Intersection ID: 10023016	Main Street: CENTER_PARK_DR	Cross Street: N/A	Location:	NE
ADA ID: EC3067A745BB	Ramp Type: PerpDiag	Initial Pass/Fail: Fail	Overall Compliance: No	Severity Score: 13.75

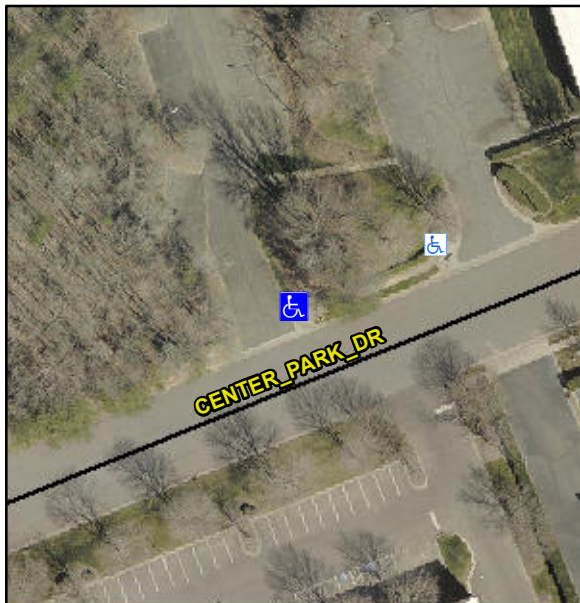
Codes/Mitigation Info/Possible Solution			Field Measurements/Component Compliance								
	Possible Solutions:		Remove & Replace Curb Ramp With Two New Directional Ramps or Equivalent.			Compliance	Description	Data	Compliance	Description	Data
						N/A	Ramp Length (in)	47.0	No	Ramp Slope (%)	9.2
						Yes	Ramp Width (in)	51.0	No	Ramp XSlope (%)	2.3
						N/A	Flare Type LT	N/A	N/A	Flare Type RT	N/A
						N/A	Flare Slope LT (%)	N/A	N/A	Flare Slope RT (%)	N/A
						N/A	Flare Traversable LT?	N/A	N/A	Flare Traversable RT?	N/A
						N/A	Landing Length (in)	N/A	N/A	DWS Provided?	N/A
						N/A	Landing Width (in)	N/A	N/A	DWS Contrast?	N/A
						N/A	Landing Slope (%)	N/A	N/A	DWS Length (in)	N/A
						N/A	Landing X Slope (%)	N/A	N/A	DWS Full Width?	N/A
Surveyor Notes:		N/A			N/A	Landing Curb? (Y/N)	N/A	N/A	DWS Offset (in)	N/A	
PROW/ADA:		R304.2.2, R304.5.3			N/A	Shared Landing?	N/A	N/A	Gutter Slope (%)	N/A	
					N/A	Gutter Ponding?	N/A	N/A	Gutter X Slope (%)	N/A
